Our Ref: P-17171

RE: MP 10_0154 MOD 3 HILLY STREET MORTLAKE - RESPONSE TO ADDITIONAL INFORMATION REQUEST

Figure 1: Extract of strata plan showing approximate outline of proposed gym

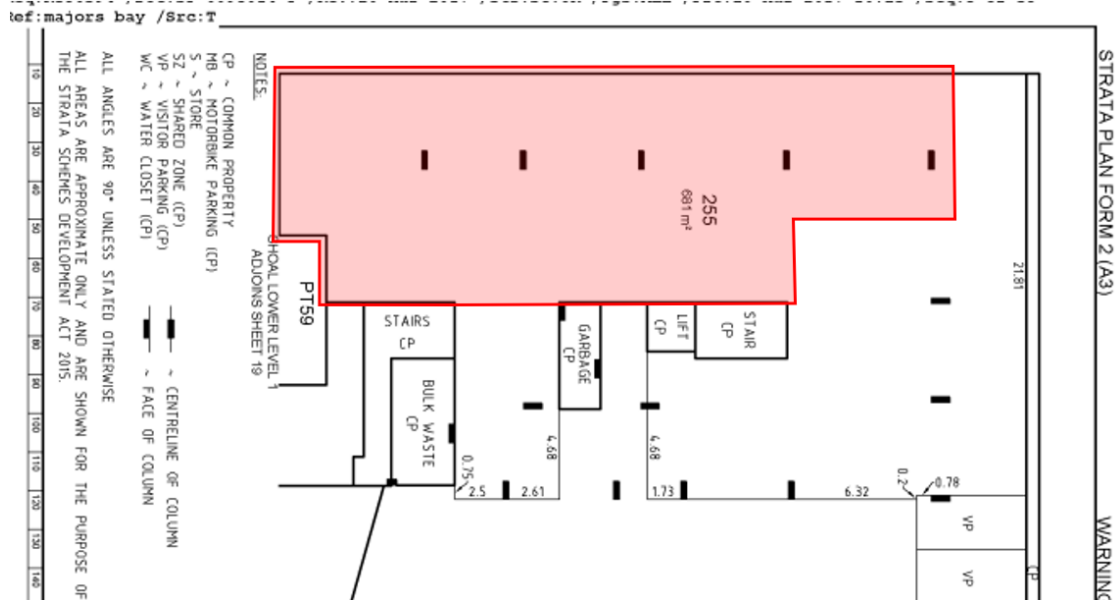
3.1. The number of car parking spaces (based on the required location/number approved by DA 513/2013 as modified by Council) required to be removed to accommodate the proposed gym.

3.3. Robust justification for any reduction in residential car parking rates approved as part of the Concept Plan and DA 513/2013.

A total of eleven (11) residential car spaces are proposed to be deleted to accommodate the proposed 373m² gym.

It is also worth noting, as shown in the approved strata plan for the development at **Attachment 2**, that the car spaces approved in DC 513/2013 (as modified) and proposed to be converted to a gym, have not been allocated to any particular residential dwelling. They remain in the proponent's ownership. Therefore, any reduction in parking spaces does not affect the allocation of parking spaces to existing residential allotments.

The most relevant section of the strata plan is shown on the following page, with the approximate area proposed to be used by the gym shown red.
